COCONUT LANE RESIDENCE

NEW TWO-STORY RESIDENCE WITH UNDERSTORY

FINAL SUBMITTAL

DRB24-1051 / 12-10-2024

C-1

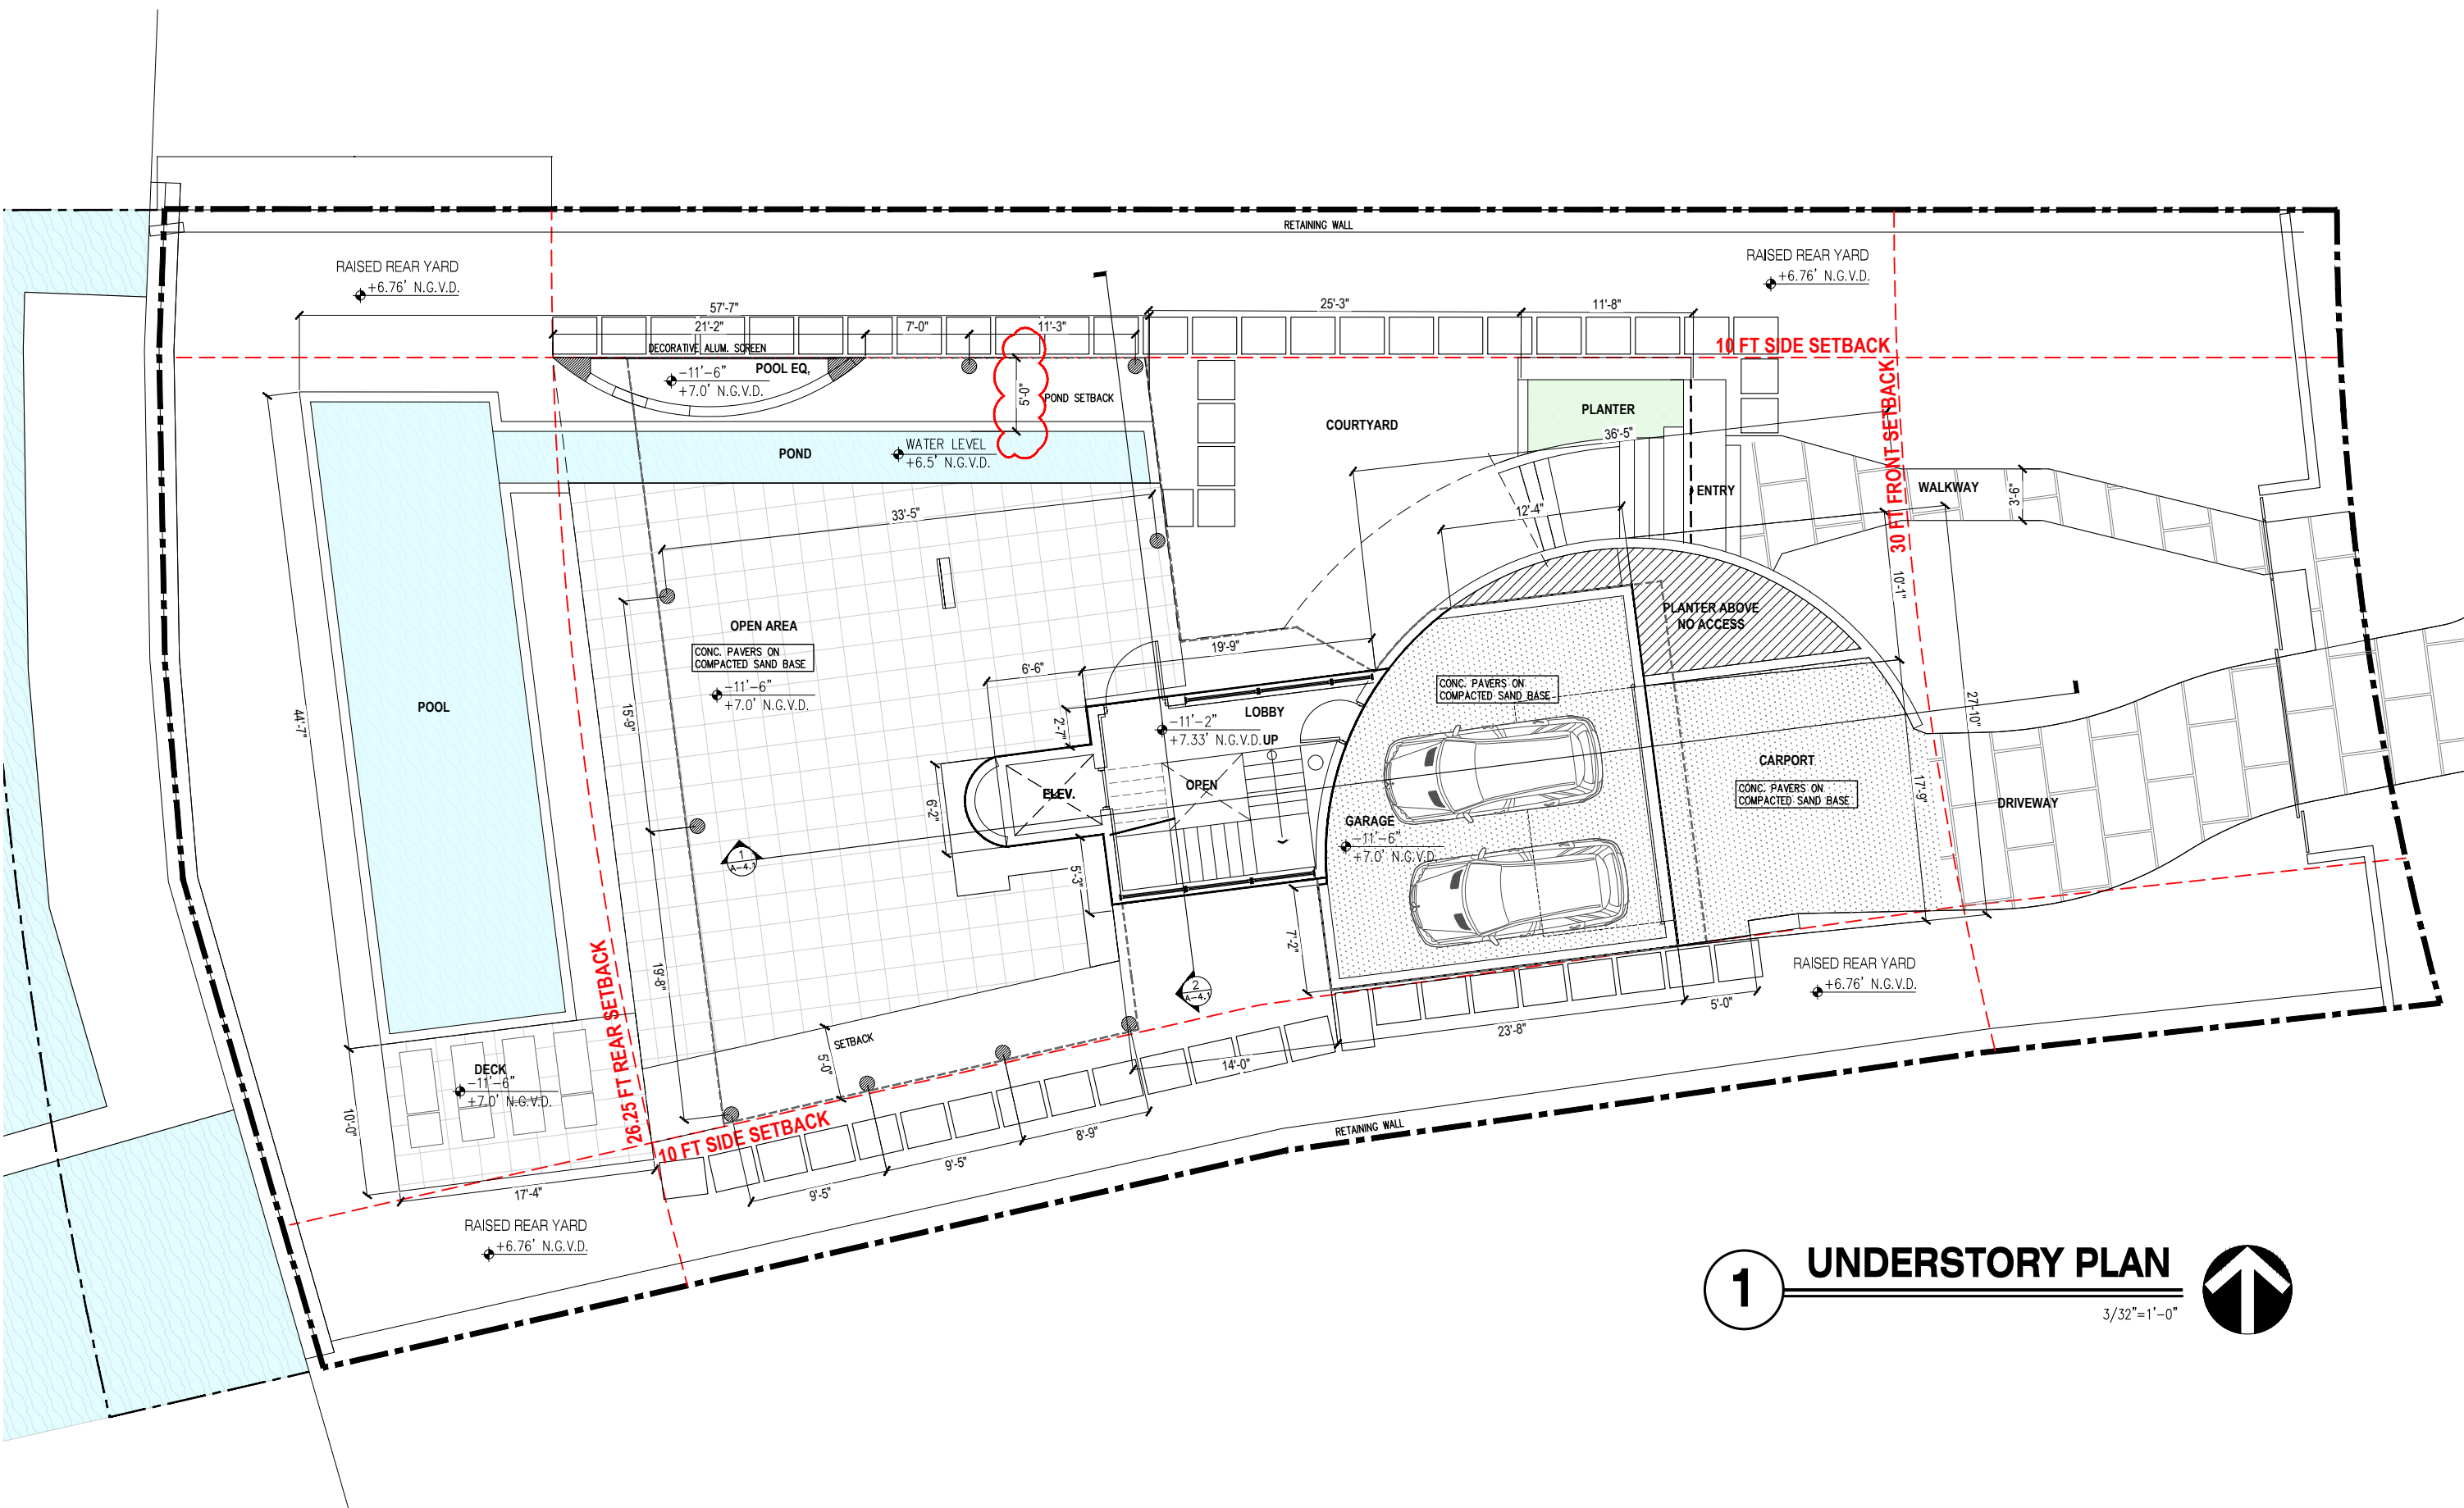
BEFORE
COMMENT:
INCREASE OPENINGS TO
FRONT VOLUME

AFTER
EXTRA OPENINGS
ADDED/ENLARGED,
HEIGHT REDUCED,
OPEN STAIR ADDED
